PSE State Diagram Update and Corrections

Jean Picard, Texas Instruments

IEEE 802.3bt Task Force

January 2017

Comment 234

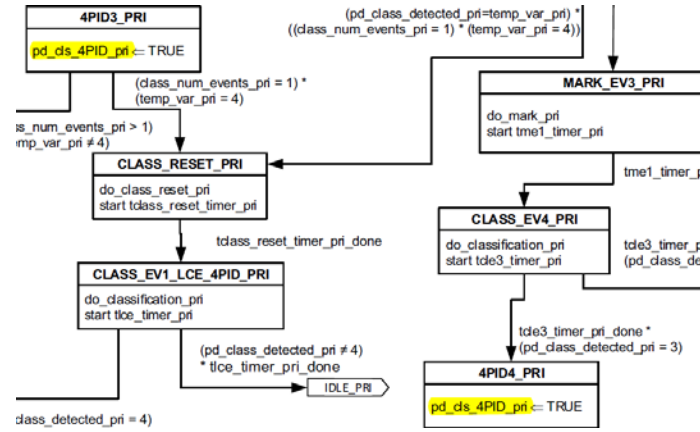
- pd_cls_4PID_xyz is missing from the list of variables.
- pd_cls_4PID_xyz is strictly the result of a very specific 4PID test method (3-finger class and parallel detection).
 - If the PSE uses the staggered detection, the pd_cls_4PID_xyz will never be set. In this case, if the other alternate is already powered it is obvious that it is 4P capable (see comment **233** slide), and the state of pd_cls_4PID_xyz is a “don’t care”.
- Remedy: Insert these (similar for sec alternate)

pd_cls_4PID_pri:

This variable indicates 4PID and Type 3 or Type 4 dual-signature PD has been established by using the method to generate 3 class events on the Primary Alternative.

TRUE: PD is a candidate for 4-pair power.

FALSE: PD not a candidate for 4-pair power OR the PSE has not used the method to determine 4P capability by generating 3 class events.
